Service Note			
Product	Description:	Service note no.	
VoiceLive Touch	Oscillation problems	SNo-T0173

Where to find the 4 resistors:

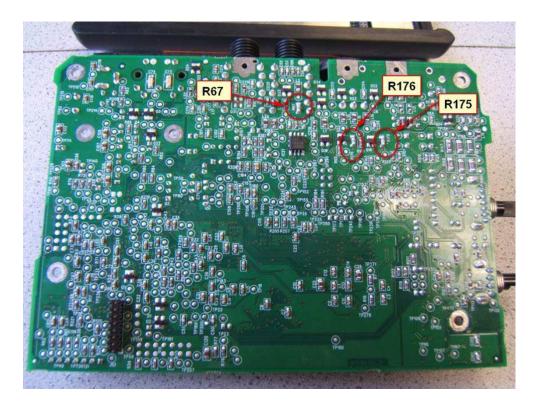
Using a long snake will occasionally result in the outputs oscillating. This can happen for PCB revisions DAC, DAD and DAE

Changing the values of four resistors (R66, R67, R175, R176) from 39 ohms to 150 ohms on the main board solves this.
